STAFF REPORT: 03/25/2025 REGULAR MEETING

APPLICATION NUMBER: HDC2025-00053

SCOPE: TRIM TREES AND REMOVE BRUSH ALONG OVERHEAD POWER LINE EASEMENT AND PUBLIC RIGHTS-OF-WAY

Figure 3, New Center Area HD by Applicant: showing extent of tree and brush trimming and removal along overhead powerlines. The red box was added by HDC staff to show locations of photos and observations.

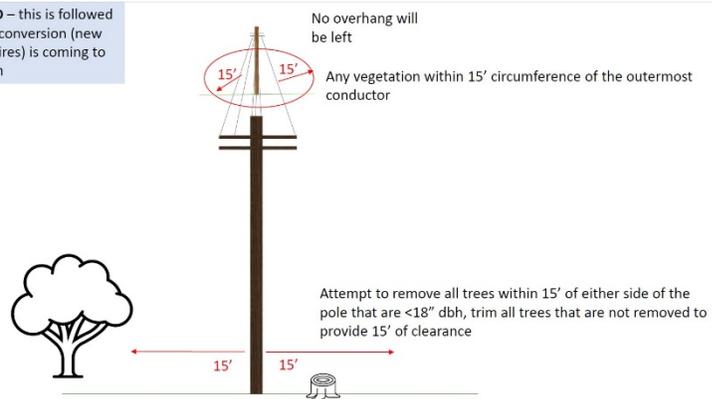
- Staff visited and photographed the proposed sites in each of the three historic districts (see figures 1-3 and site photos 1-5) and observed the following conditions: near all vegetation would be considered weed species immediately in or along the alley edges. Staff has no issue with clearing these trees, vines and shrubs.

Figures 4&5, tree trimming maintenance practice by Applicant: showing clearance distances from utility equipment where trees and vegetation will be trimmed or cut.

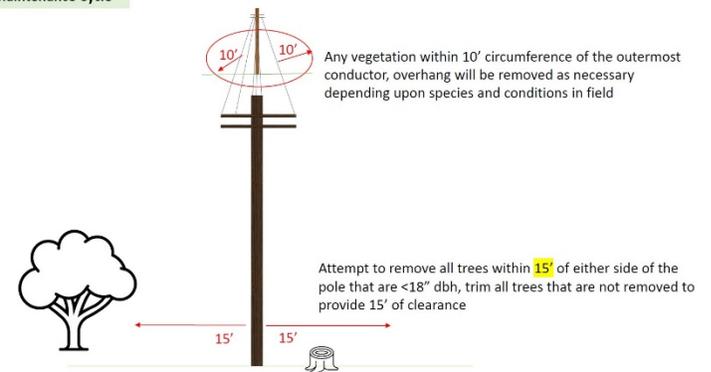
- Staff observed that past work in other neighborhoods by contractors to the utility company includes a trimming practice called, "sky to ground" where trees are limbed from the sky to the ground plane within the easements and their setbacks. This practice has left trees unbalanced and exposed to disease, thus, potentially causing harm to property by the loss of canopy and potential damage should the tree fall on private property (*see site photo 3*). It is staff's observation that the work proposed in this application under "Enhanced" and "Standard" maintenance practices is NOT representative of this "sky to ground" practice of work.

- Staff recommends a less aggressive trimming practice that is 10' rather than the 15' clearance radius for historically significant trees, which is partially reflected in the distinction of primary and secondary lines.
